# St Peters Interchange Recreational Area Sub-Plan Supplementary Comments from City of Sydney

These are the City of Sydney's additional comments arising from the presentation at the UDRP meeting held on 21 March 2017.

Adapted from McGregor Coxall/CHROFI

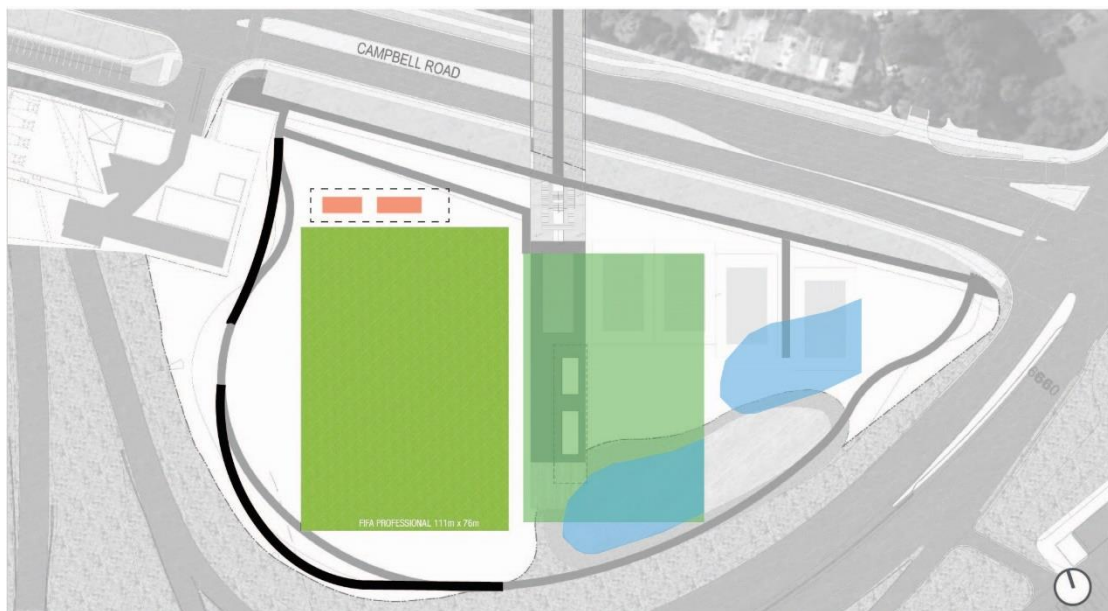
*The City requests the design be amended to achieve a two field configuration, developed with appropriate lighting and fencing provisioned with a synthetic playing surface to maximise community utilisation, incorporating the supporting amenities described below.*

1. The spatial investigations reveal the potential of this site to sustain two fields:
  - a. Compact 98m long x 66m wide (approx. 6500m<sup>2</sup>)
  - b. FIFA Professional 111m long x 76m wide (approx. 8500m<sup>2</sup>)

2. This potential relies on:
  - the reconfiguration of detention requirements to the eastern end of the site and/or the conversion of some/all detention capacity into sub-surface storage.

- the fields being in close proximity, with proposed supporting amenities relocated from current position. There is an opportunity for supporting amenities to be integrated with the Campbell Street Berm and/or land bridge termination/viewing deck.
3. The approximate scale of supporting amenities is provided below:
- Change Rooms, including accessible toilet+shower (30-32m2 each for home and away)
  - Public Toilets (M+F with communal wash basin ) + accessible (25m2 + 7 m2)
  - Maintenance and Store (30-35 m2 per field)
  - Café/Kiosk/Office (35 m2)
